UNITED STATES PATENT AND TRADEMARK OFFICE

Office Action Summary	Application No. 10/585,905	Applicant(s) WAGNER ET AL.	
	Examiner ROCCO ITALIANO	Art Unit 3746

DETAILED ACTION

FIG. 1

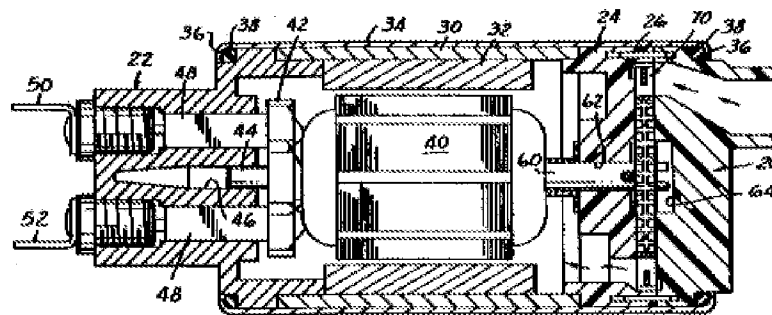
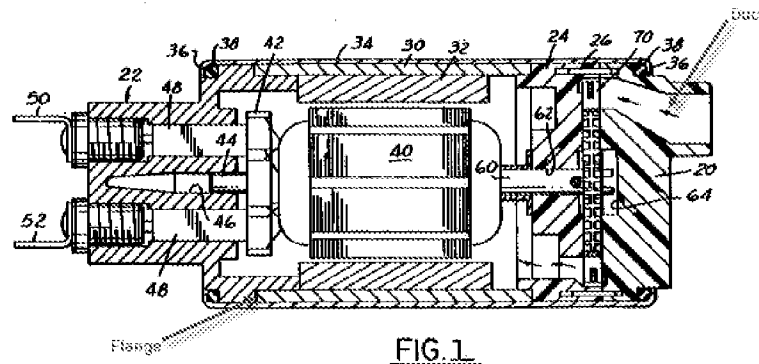
In regards to claims 1 and 4, Tuckey discloses a fuel pump for an internal combustion engine, analogous to a fuel feed unit for delivering fuel as described by the applicant. Tuckey discloses: an electric motor (40); a cylindrical flux ring (30) regarded as the equivalent to the applicant's electric motor stator ring; permanent magnets (32), or magnetic shells, arranged in a comparable manner to the applicant's arrangement whereby the permanent magnets (32) are arranged inside the cylindrical flux ring (30); a motor casing (34), or casing part, to accommodate the cylindrical flux ring (30) or stator ring (see column 1, lines 50-55 and Fig. 1). The disclosure according to Tuckey differs with respect to the applicant's invention in that no specific detail is provided teaching of a one-piece body comprising the stator ring (30) and an adjoining component of the

motor casing and/or of the permanent magnets (32). However, it would have been obvious to one having ordinary skill in the art at the time the invention was made to integrate the stator ring and adjoining components in order to achieve a one-piece body, since it has been held that forming in one piece an article which have been formerly formed in a plurality pieces and put together involves only routine skill in the art.

With respect to claim 5, Tuckey illustrated within the Fig. 1, the body (34) comprising the stator ring (8) has a flange portion for joining a connection piece (22) intended for the connection of a fuel line (50, 52) (see Fig.1 labeled by examiner for clarity provided below).

In regards to claim 6, Tuckey discloses further a bearing (60) for the rotor which can be seen in Fig.1 as being provided in an analogous manner as depicted by the applicant (see Fig. 1).

In regards to claim 7, it can be seen in Fig.1 according to Tuckey that the cylindrical flux ring (30) or stator ring is joined in one piece to a component (20) having a duct (see Fig 1. labeled by examiner for clarity).
